Amendments to the Design Manual: Barrier Free Access 2008
(September 2015)

5. Figure 45

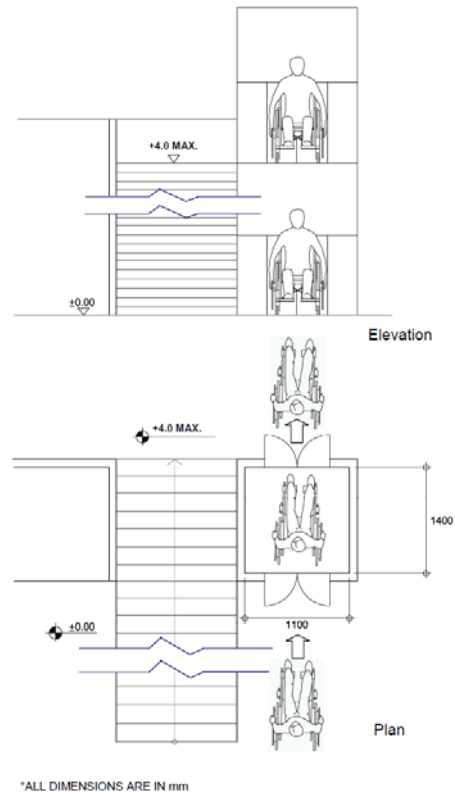
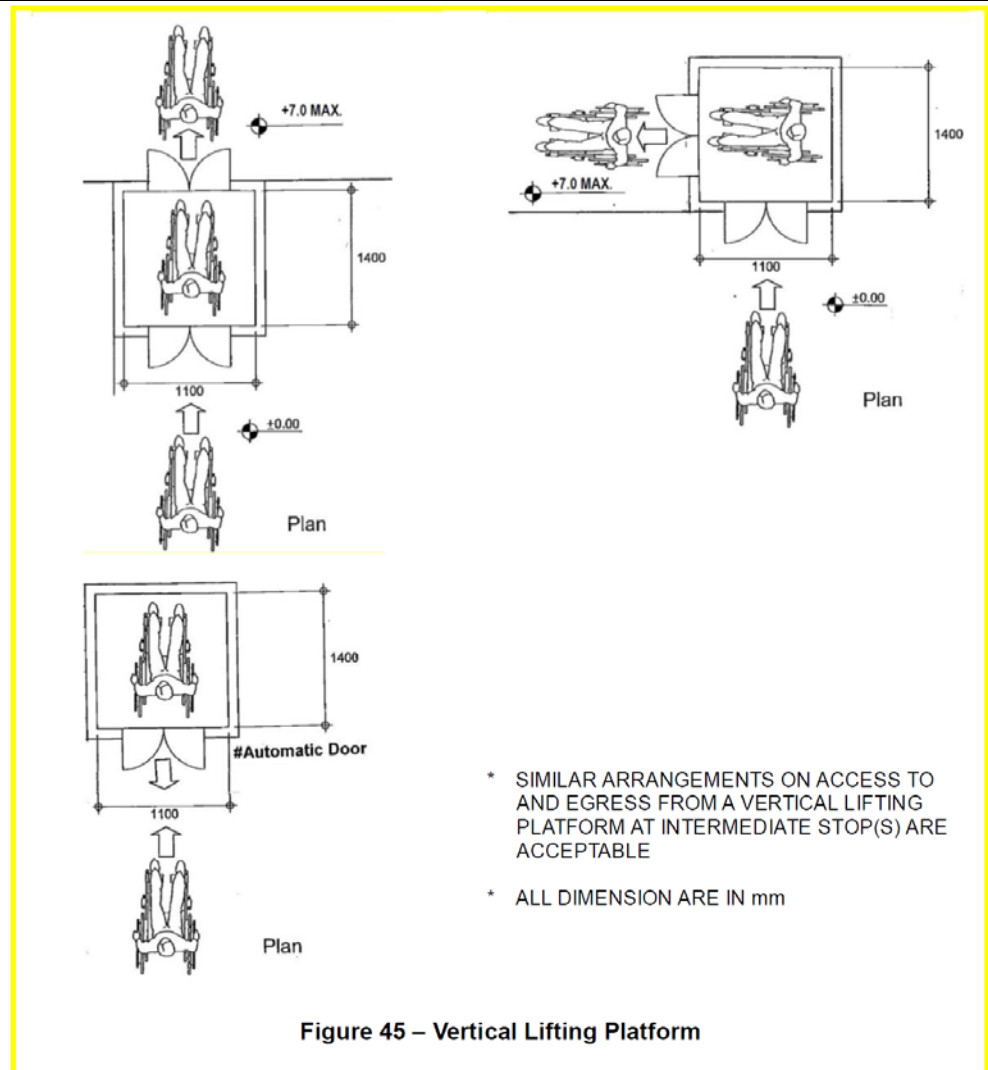
3. Paragraph 5.5 B(a)(ix) in Chapter 5 ²	the maximum travel should be 4000mm;	the maximum travel should be 7000mm;
4. Paragraph 5.5 B(a)(xii) in Chapter 5 ³	The landings to a vertical lifting platforms at the 2 access levels should be in opposite directions so as to eliminate the need for the wheelchair to back-out.	Every landing to a vertical lifting platform should be in opposite direction or located at 90° relative to all other landings so as to eliminate the need for the wheelchair to back-out. This requirement does not apply to a vertical lifting platform which is provided with power-operated and automatically controlled horizontally sliding or swing doors. The kinetic energy of the automatic doors should not exceed 10J.

³ To control the arrangement on access to and egress from a vertical lifting platform with a maximum travel height up to 7000mm which may serve more than two access levels. Back-out arrangement of the wheelchair is allowed if a vertical lifting platform provided with automatic doors similar to an accessible lift with automatic doors.
